TIQA Cafe Sign Permit Application

Subject: Re: TIQA Cafe Sign

Blade Sign.jpg
465K

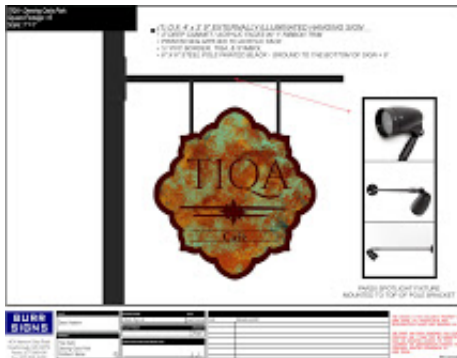
In my previous e-mails, I described the fact that we had concerns about the internal illumination (which has been addressed). I also expressed concern about the thickness of the cabinet. Now that there is no internal illumination, I'm wondering why the sign needs to be 4 inches thick, or even why it needs to be a cabinet. With this type of sign, the sign panel need only be the thickness of the stock material.

Regarding the solar panel, can you tell me where it is proposed to be installed? Also, the specification provided doesn't indicate its dimensions. Is the solar panel proposed because you aren't able to run power to the sign?

Response: Not clear what the issue is. Becoming concerned about this effort. This is the third design I have presented the city and it sounds like you are looking for a fourth. I don't have the energy to keep presenting options nor am I willing to turn over the design of our sign to the city.. There is nothing in any document you presented to me that limits thickness. I am also not clear how 4" is too thick. If you are not willing to approve this, let's go to whatever the next step is.

Response: The installation for the sign is on the corner of State Street just after the parking lot entrance/exit. We are green oriented and didn't want to tear up the grass and sidewalk to illuminate the sign.
